WILLIAMSON COUNTY, TEXAS

CHANGE ORDER NUMBER: 4

Project:	<u>22IFB57</u>
Roadway:	<u>CR 401</u> <u>Reconstruction</u>
CSJ Number:	<u> </u>

Change Order No. 4 Reason for Change

PLAN - 18IN WATERLINE RELOCATION

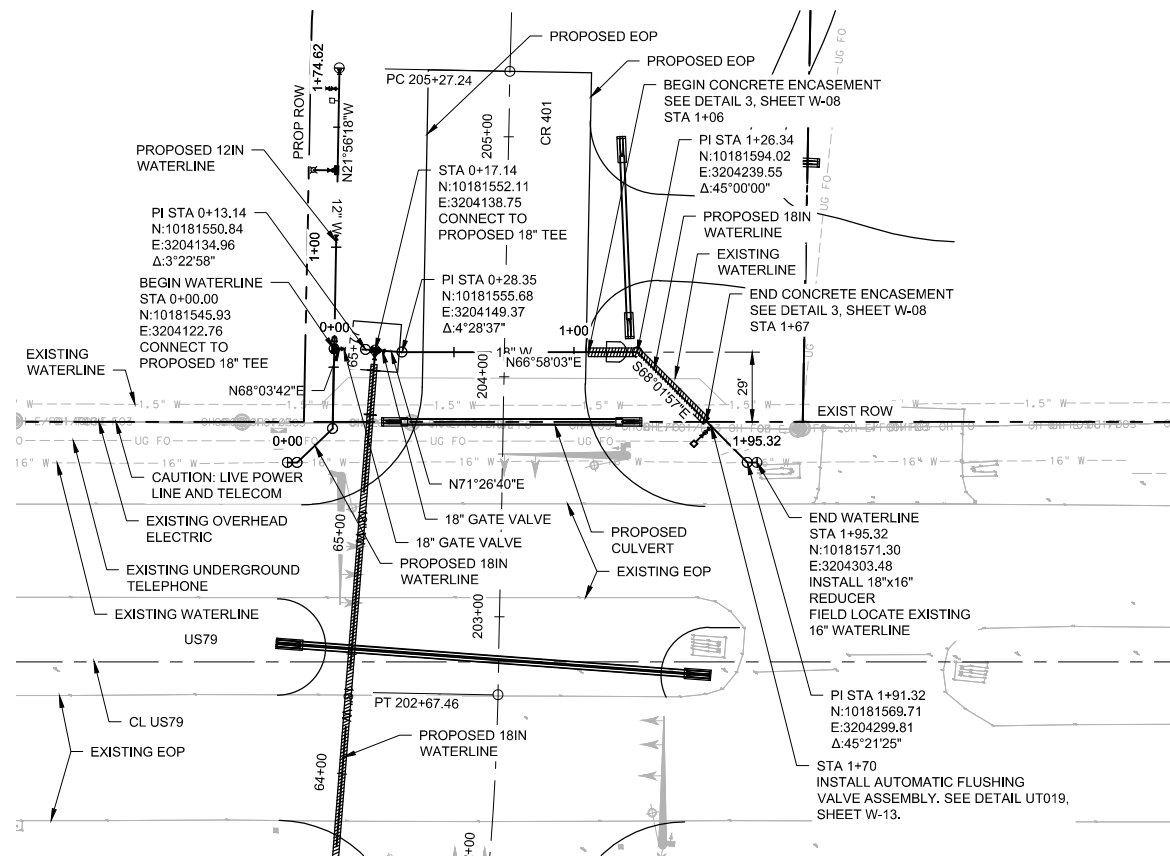
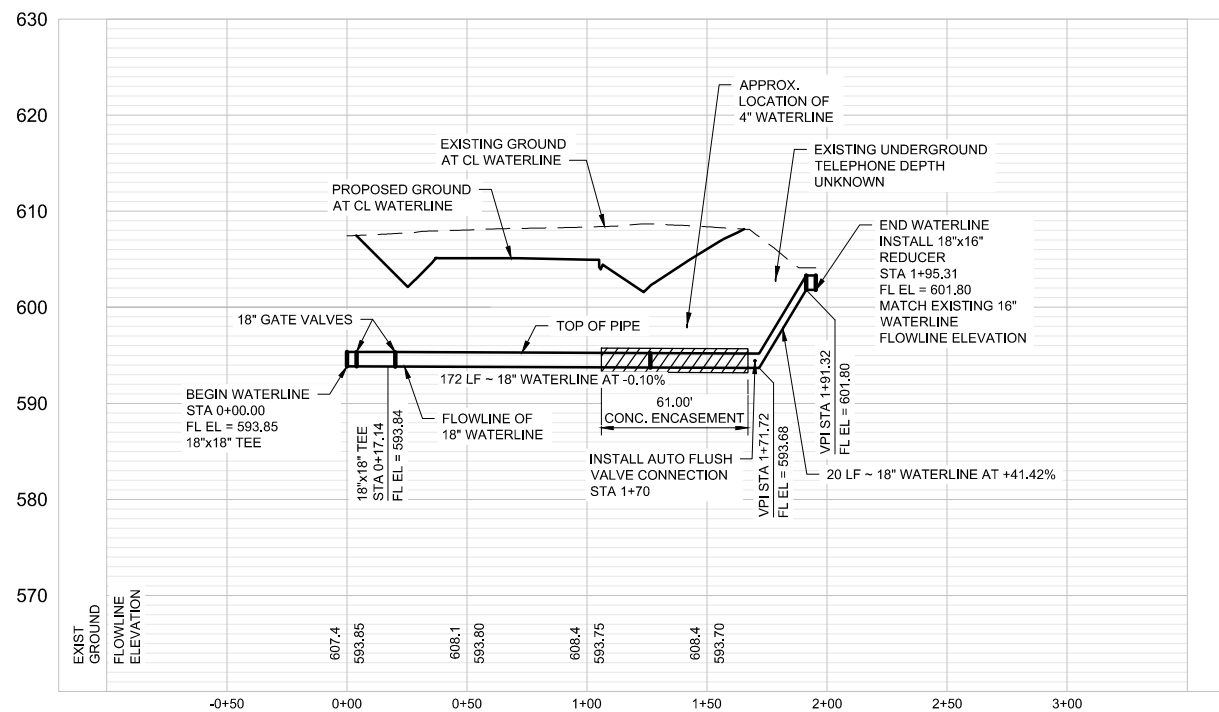
This Change Order revises and adds additional items to the Contract for the adjustments needed to the City of Taylor water line on the north side of US 79 that conflicts with the proposed roadway and ditch cuts. This line is also being upsized to stay consistent with the proposed water line on CR 401.

PLAN - 12IN WATERLINE

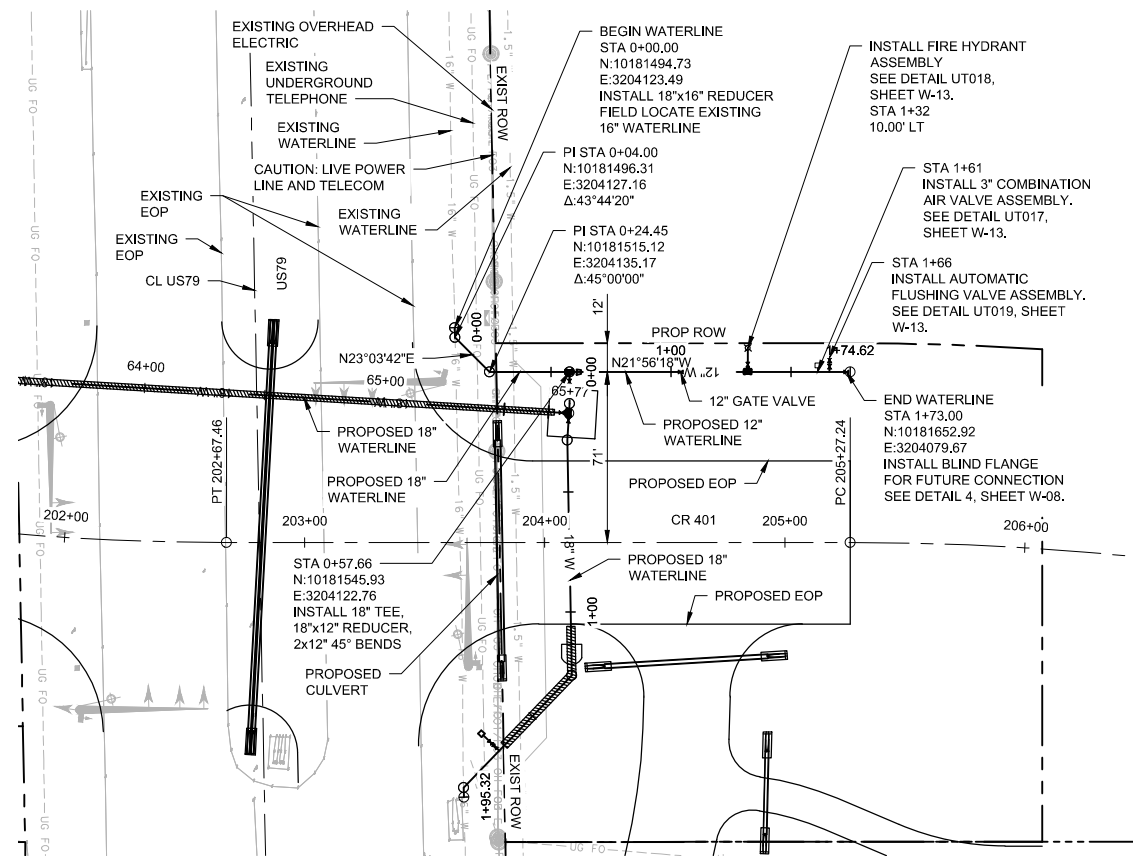
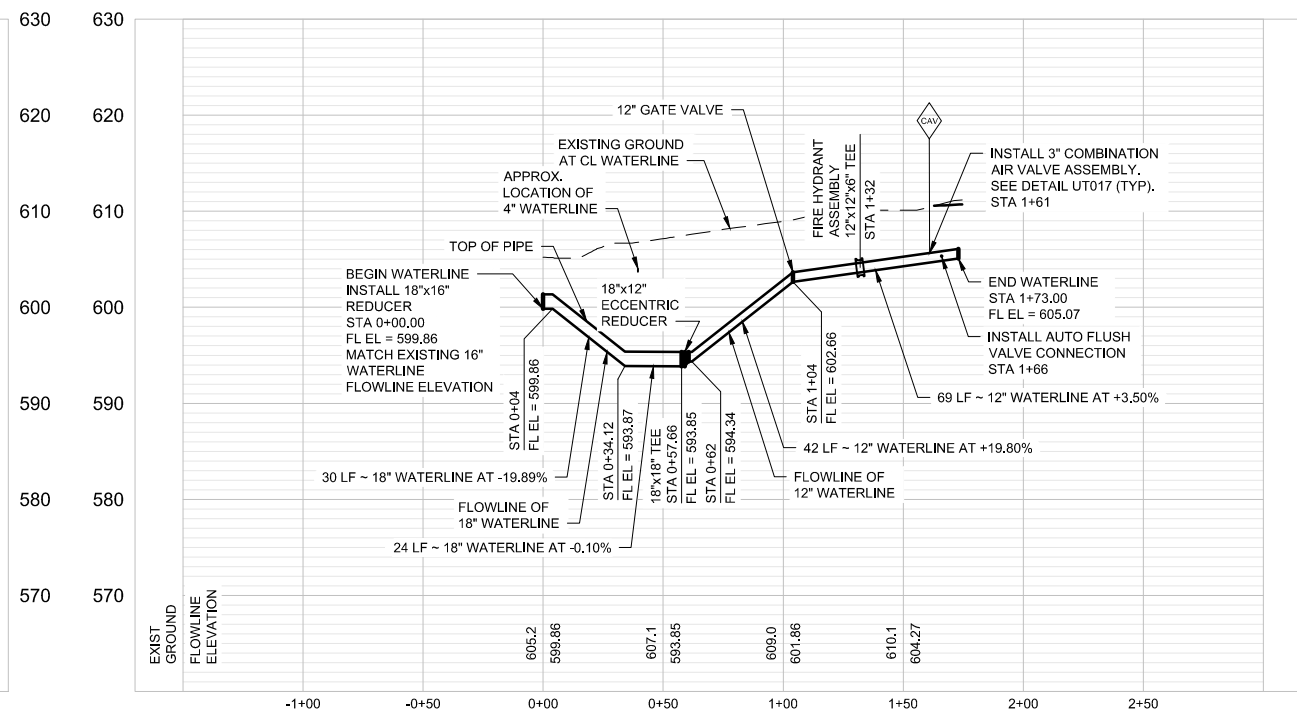
This Change Order also addresses the need for an additional fire hydrant requested by the City of Taylor on the southeast side of US 79 and proposed CR 401.
